## ***Interactive comment on “The seamless and multi-model coupling between atmosphere, land, hydrology, ocean, waves and sea-ice models based on SURFEX surface model using OASIS3-MCT” by Aurore Voldoire et al.***

Received and published: 28 July 2017

Figure A: Domain-averaged total water content (mm) for the NOCPL run (in red) and for the CPL run (in blue).

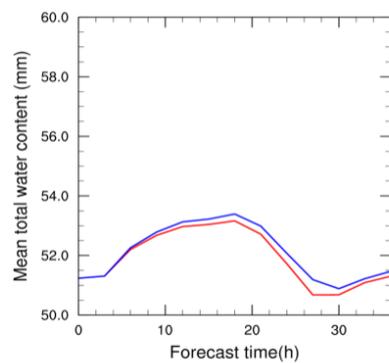
RC: Concerning the MESONH-NEMO section, the illustration of the coupling effect on the tropical cyclone structure is not clear (and the units are missing). A better illustration would be to present the time evolution of the cyclone intensity or the water content averaged over the domain region.

AA: The evolution of the domain-averaged integrated water content is shown in Figure 1 (below, in this document) for the MESONH-NEMO model over the Indian Ocean. It shows that in the CPL run, there is systematically slightly more water than in the NOCPL run, but it does not show the impact on the structure of the system, and especially on the position and intensity of the eyewall represented by the region of maximum values of total water, which is what we want to illustrate. So, to render Figure 7 (old Fig. 8) more readable and in order also to enlarge the size of each plot, we have decreased the number of panels shown from 6 to 4. Only the 18 h and 30 h forecast ranges have been retained. The units are also shown on Figure 7.
